PLAT COMMITTEE

January 8, 2025

Case Number:	2024-PLT-069
Property Address:	2163 and 2179 North Illinois Street (<i>Approximate Addresses</i>)
Location:	Center Township, Council District #12
Petitioner:	Near North Development Corporation, by Leslie Steinert
Zoning:	MU-2 (RC); D-8 (RC) (Pending)
Request:	Approval of a Subdivision Plat to be known as 22 nd and Illinois Townhomes Subdivision, dividing 1.2 acres into 23 single-family attached lots and one block.
Waiver Requested:	None
Current Land Use:	Undeveloped
Staff Reviewer:	Michael Weigel, Senior Planner

2024-PLT-069 ; Secondary Plat

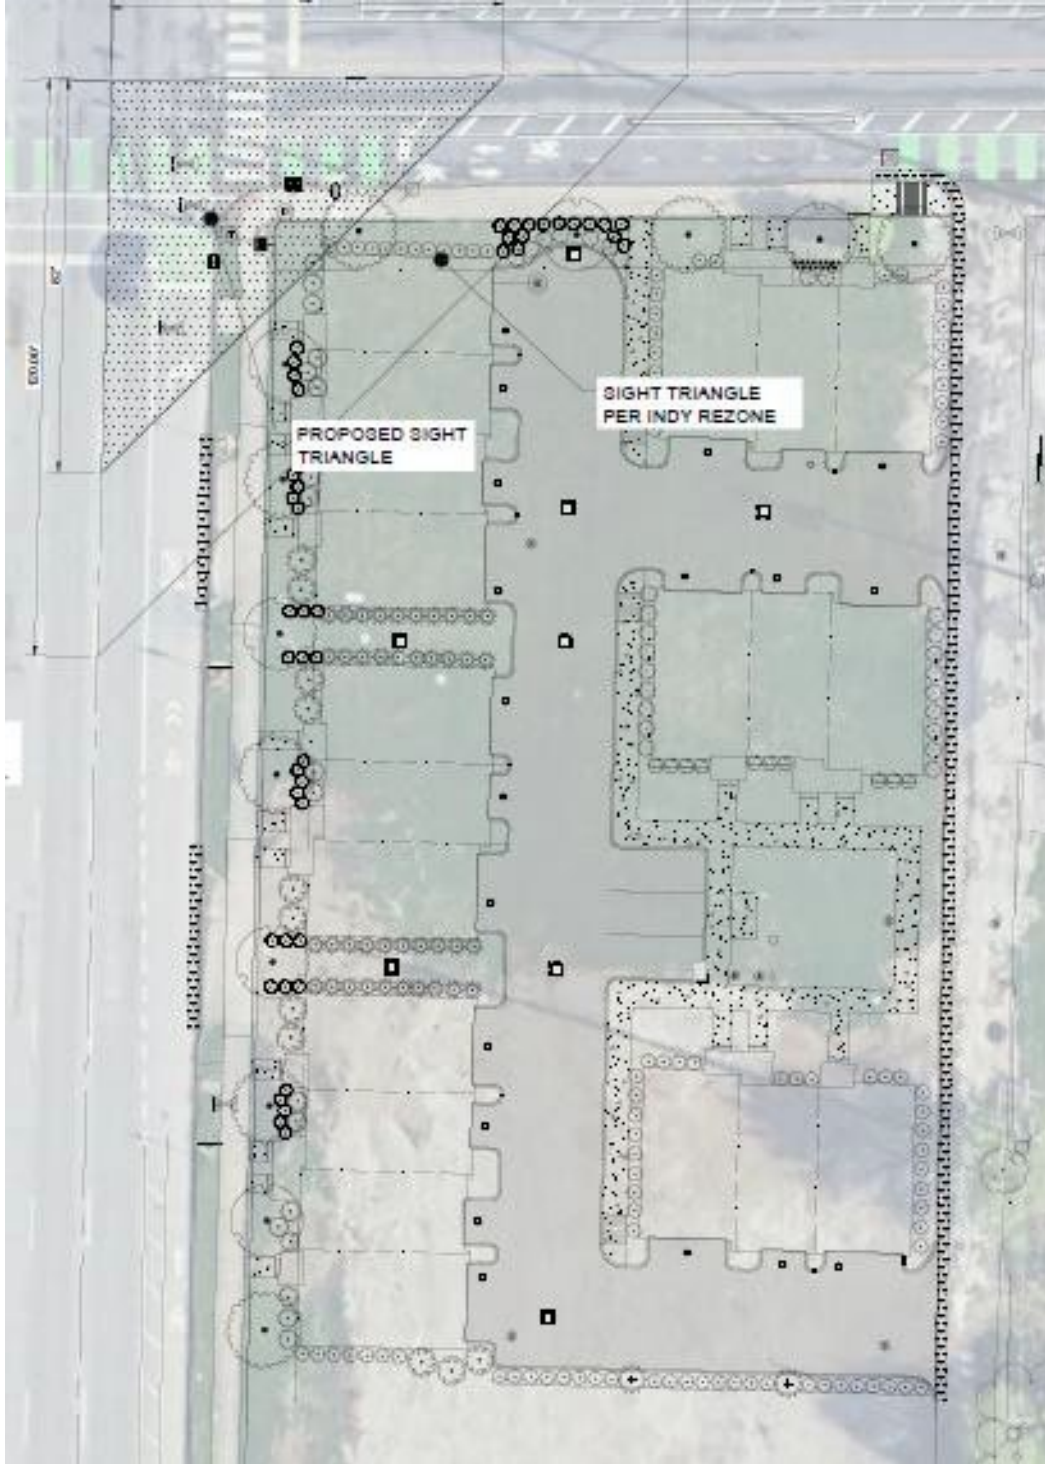
Staff recommends that the Plat Committee **approve** and find that the plat, file-dated November 4, 2024, complies with the standards of the Subdivision regulations, subject to the following conditions:

1. That the applicant provides a bond, as required by Section 741-210, of the Consolidated Zoning and Subdivision Ordinance.
2. Subject to the Standards and Specifications of Citizens Energy Group, Sanitation Section.

3. Subject to the Standards and Specifications of the Department of Public Works, Drainage Section.
4. Subject to the Standards and Specifications of the Department of Public Works, Transportation Section.

5. That addresses and street names, as approved by the Department of Metropolitan Development, be affixed to the final plat prior to recording.
6. That the Enforcement Covenant (Section 741-701, of the Consolidated Zoning and Subdivision Ordinance) be affixed to the final plat prior to recording

7. That the Site Distance Covenant (Section 741-702, of the Consolidated Zoning and Subdivision Ordinance) be affixed to the final plat prior to recording.

8. That the Sanitary Sewer Covenant (Section 741-704, of the Consolidated Zoning and Subdivision Ordinance) be affixed to the final plat prior to recording.

9. That the Storm Drainage Covenant (Section 741-703, of the Consolidated Zoning and Subdivision Ordinance) be affixed to the final plat prior to recording.
10. That the plat restrictions and covenants, done in accordance with the rezoning commitments, be submitted prior to recording the final plat.
11. That all the standards related to secondary plat approval listed in Sections 741-207 and 741-208 of the Consolidated Zoning and Subdivision Ordinance be met prior to recording the final plat.
12. That all required internal sidewalks will be affixed to the final plat prior to recording.
13. That the traffic plan and natural infrastructure plan be affixed to the final plat prior to recording.
